CT7-2E INCREMENTAL CHANGE
MM 73-00-00
FUEL SYSTEM - INSPECTION

Release Notification Date: 03/23/2021

<u>HIGHLIGHT REFERENCE</u>	<u>DESCRIPTION OF CHANGE</u>
tk73-00-00-200-801	Technical Change: Changed the inspection of the fuel injector assembly inlet fitting in Table 602 to change the corrective action to use die 0.5625-18 UNJF-3A.
tk73-00-00-200-801	Technical Change: Changed the inspection of the fuel injector assembly inlet fitting for missing or damaged threads in Table 602.

Figure 602 Fuel Injector - Inspection

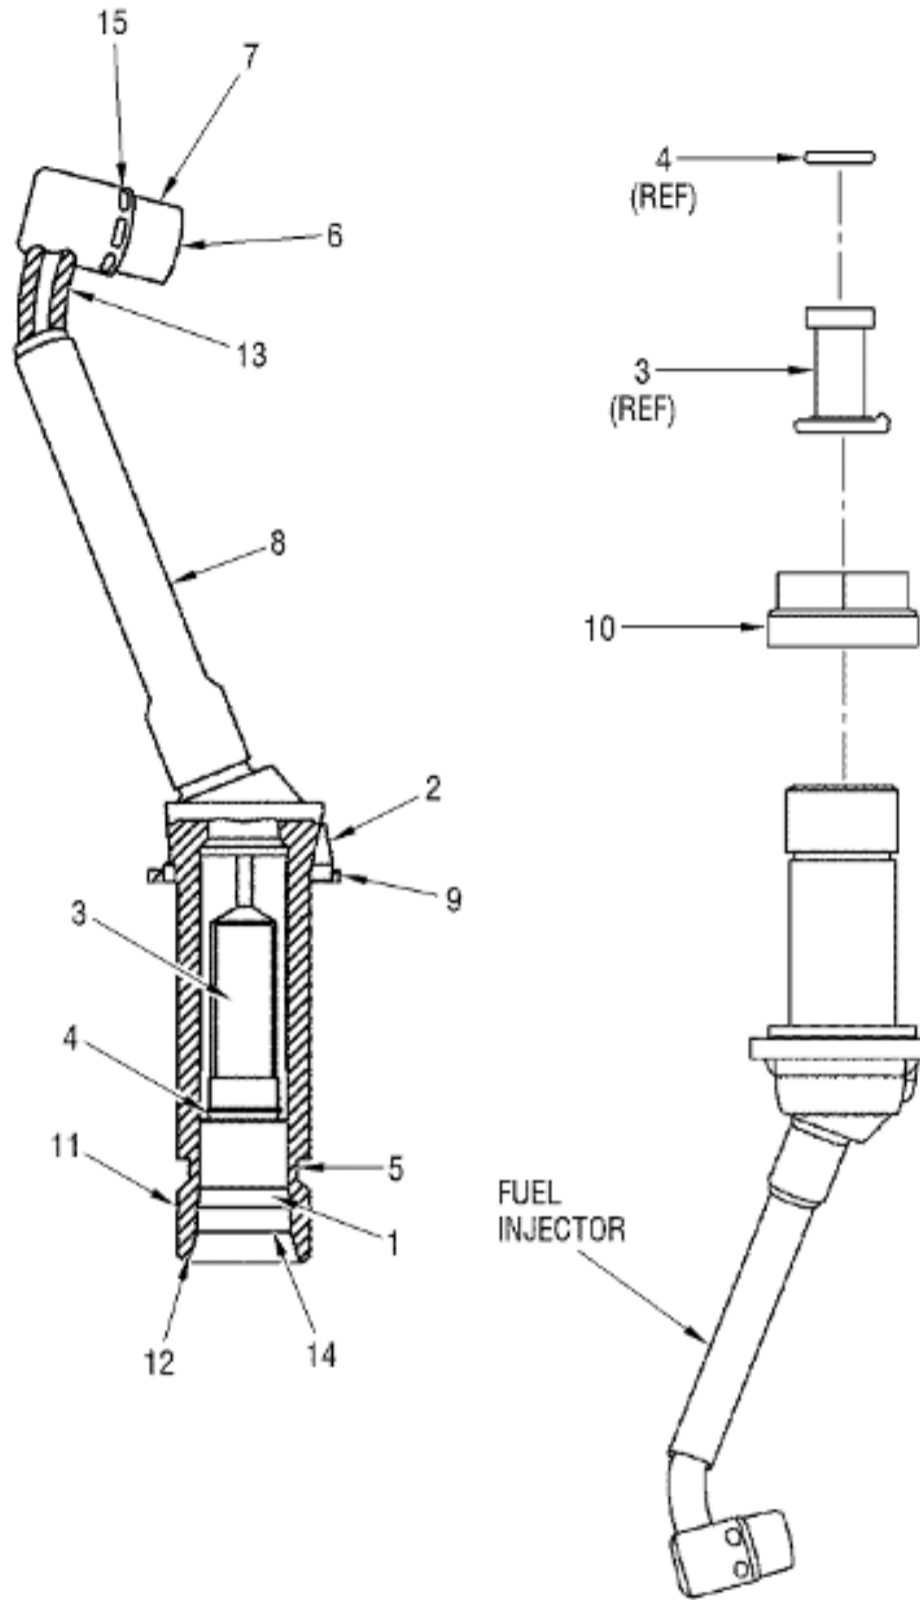
E. Inlet fitting (5) for:

(1) Cracks.	None permitted.	Not repairable.	Replace the fuel injector.
(2) Missing or damaged threads (10X visual recommended).	All threads, total cumulative 0.44 inch (11.2 mm) or less missing or damaged without high metal along the thread circumference.	All threads, 0.44 inch (11.2 mm) cumulative missing or damaged with high metal along the thread circumference that can be blended to the usable limits.	Check thread OD is within usable limits. Use a 0.5625-18 UNJF-3A die or equivalent and chase the threads.
(3) Thread OD.	Starting from the first full thread, 0.554-0.563 inch (14.08-14.30 mm).	Not repairable.	Replace the fuel injector.
(4) Broken or missing retaining ring (4).	Not permitted.	Not repairable.	Replace the retaining ring.
